Form C-103
May 27, 2004

7. Lease Name or Unit Agreement Name
RINCON UNIT

8. Well Number #413

SUNDRY NOTICES AND REPORTS ON WELLS
(DO NOT USE THIS FORM FOR PROPOSALS TO DRILL OR TO DEEPEN OR PLUG BACK TO A DIFFERENT RESERVOIR USE "APPLICATION FOR PERMIT" (FORM C-101) FOR SUCH PROPOSALS)

SITE PLAN

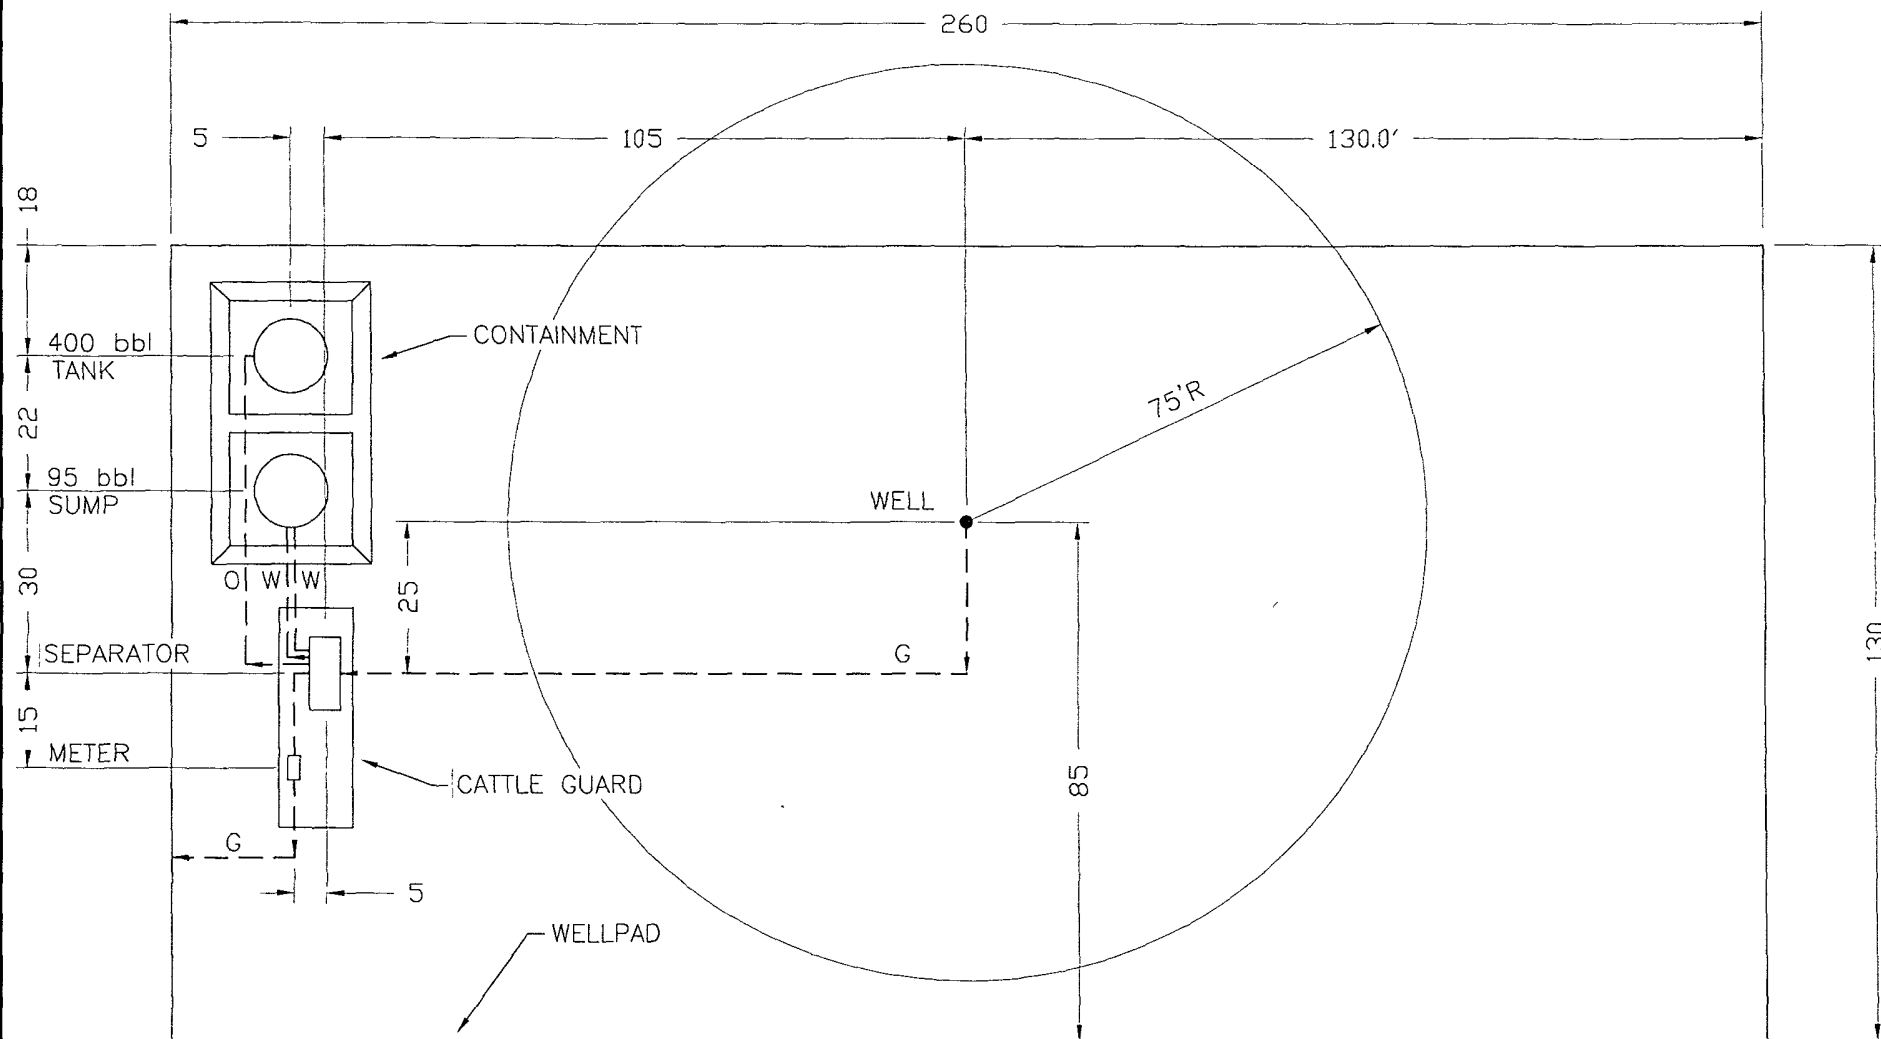
Chevron MidContinent, L.P. reports that we have changed our planned facilities for the above mentioned location. A ~400 BBL steel tank, a ~95 BBL below-grade steel tank, a separator, and an Enterprise meter run will be installed on the well pad. Attached is a basic diagram of how these facilities would be arranged on a wellsite and a basic diagram of the 95Bbl below-grade steel tank. Should you have any questions or require any additional information, please feel free to contact us at anytime.
